TO: All Proposers
FROM: Rita Kirkland
DATE: September 2, 2022
SUBJECT: Proposal Addendum No. 1
BID#: 22-991100
DATE ISSUED: September 2, 2022
THE PROJECT: Audio Visual Upgrades for Buder & Julia Davis Branches

This addendum is issued to provide a modification/addition to proposal plans and/or specifications.

● FLOOR PLAN - J. J. DAVIS BRANCH LIBRARY
 SCALE 1/8" = 1'-0"
 SAINT LOUIS PUBLIC LIBRARY

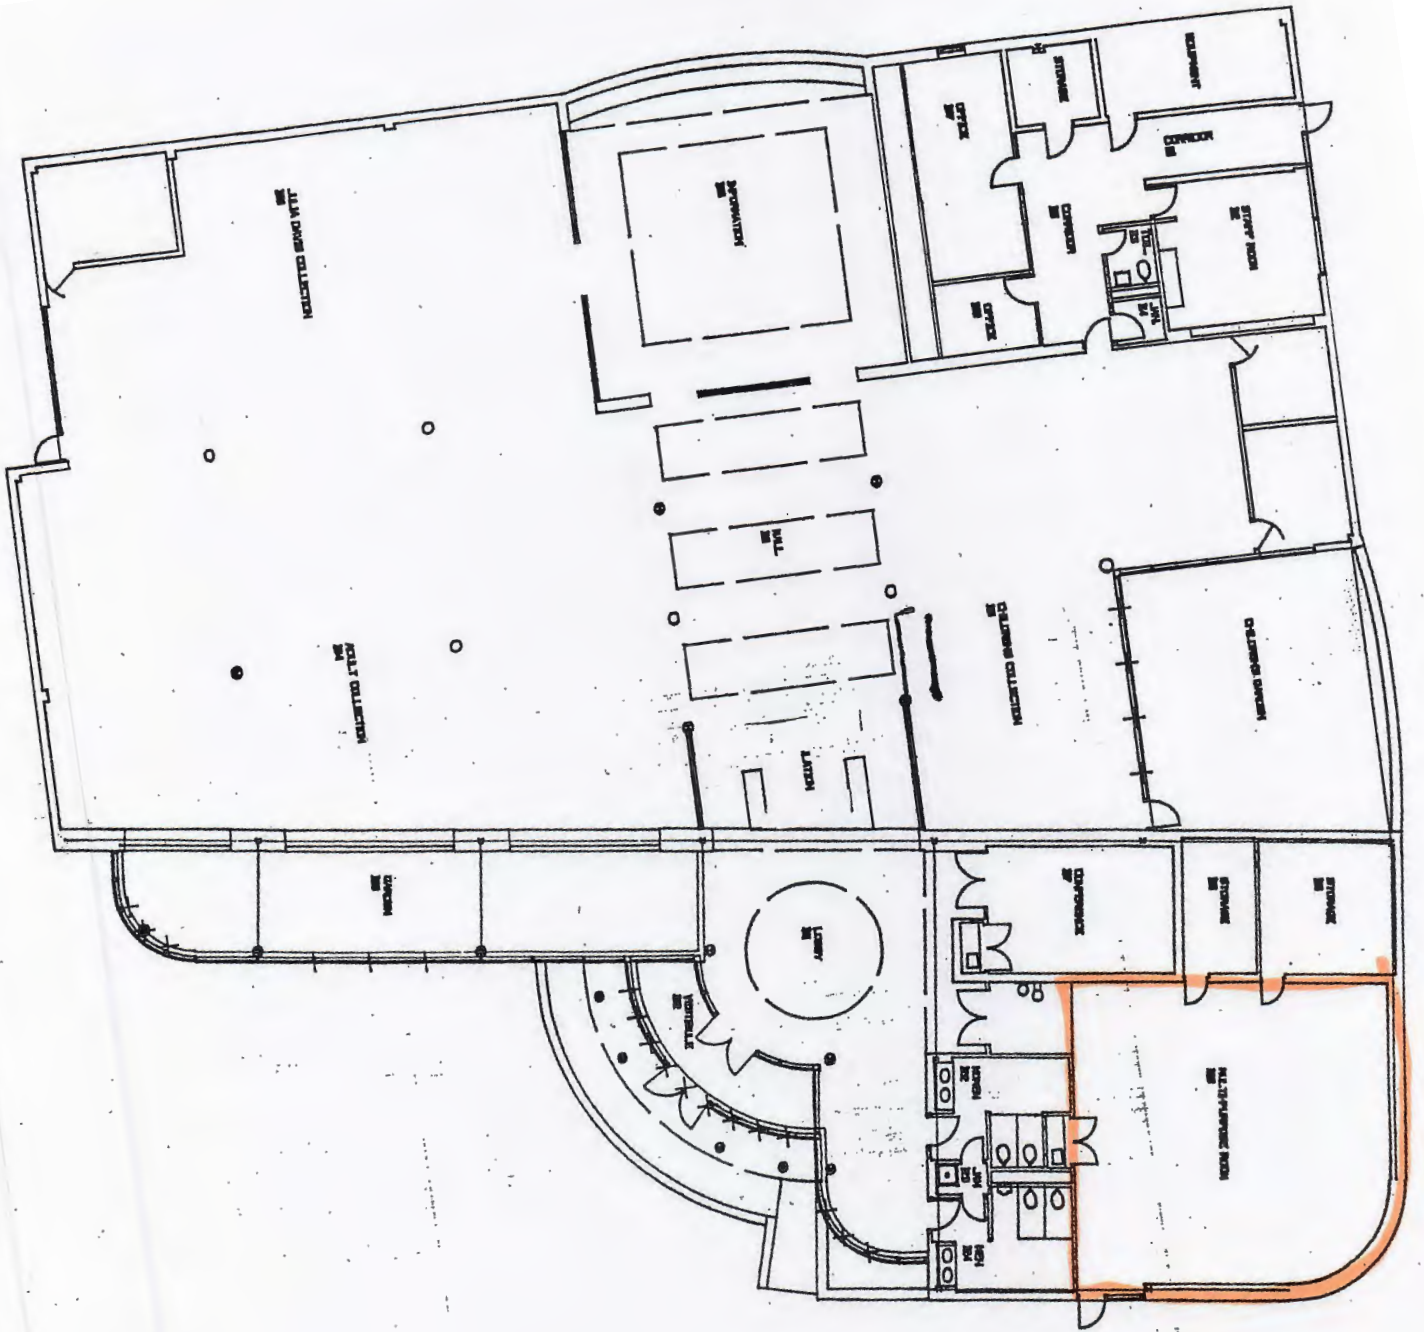
1. Wanted to follow up on any room drawings or building drawings for the locations requested in RFP.

See Attachment A. (Auditorium has been highlighted in orange on drawing.)
